BOARD ACTION REPORT – APPEALABLE ITEM

Project Name: Delray City Market

SITE PLAN REVIEW AND APPEARANCE BOARD STAFF REPORT

Application Type: Class V Site Plan, Landscape Plan,
Architectural Elevations and Waiver – Delray City Market

1	Overall Rooftop Plan 1/16" = 1'-0"
---	---------------------------------------

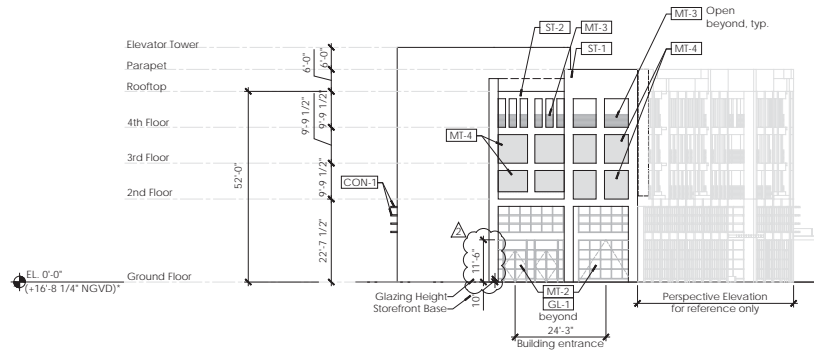
The photometric plan for the roof top parking is provided on Sheet A1.12 with the fixture details on Sheet A1.13. Lighting is provided on poles 16 feet in height. The code limits pole height to 15 feet if located within 20 feet of the edge of the structure, otherwise the pole height maximum is 20 feet. Poles are located greater than 20 feet from the edge of the structure. Lighting levels are within the minimum and maximum permitted levels.

1 North Elevation
1/16" = 1'-0"

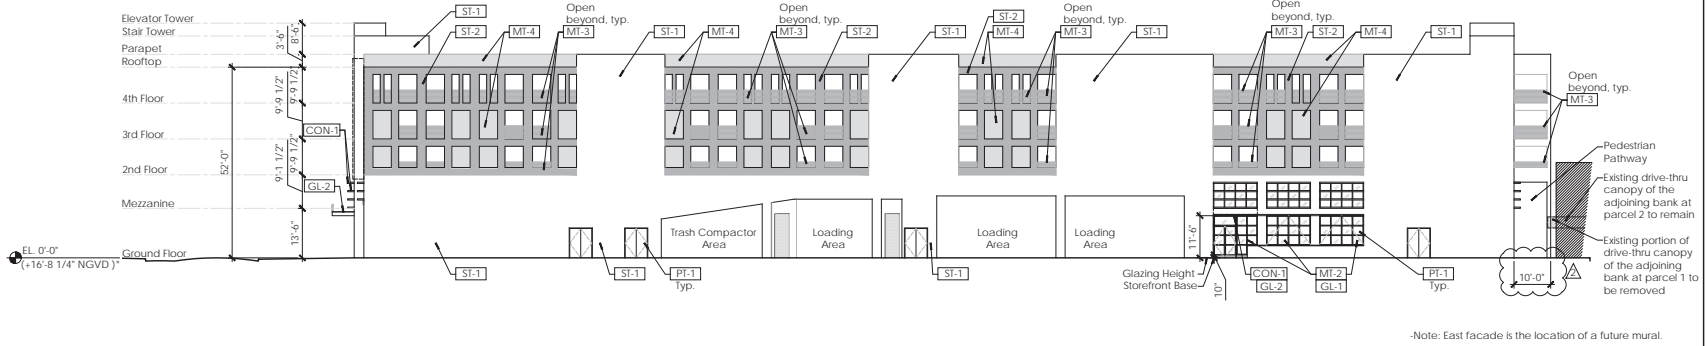
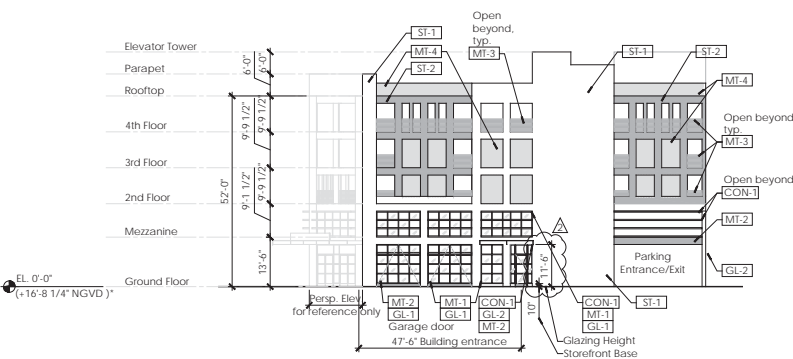
The trash and recycling room for the building is located within the rear of the building in a refrigerated area. Trash and recycling pick up is from the alley. Pursuant to LDR Section 4.6.6(C)(1), dumpsters, recycling containers and similar service areas must be enclosed on three sides with vision obscuring gates on the fourth side, unless such areas are not visible from any adjacent public rights-of-way. The new building will be serviced from a loading area accessed from the rear alley. The site plan and eastern elevations indicate that this requirement has been met.
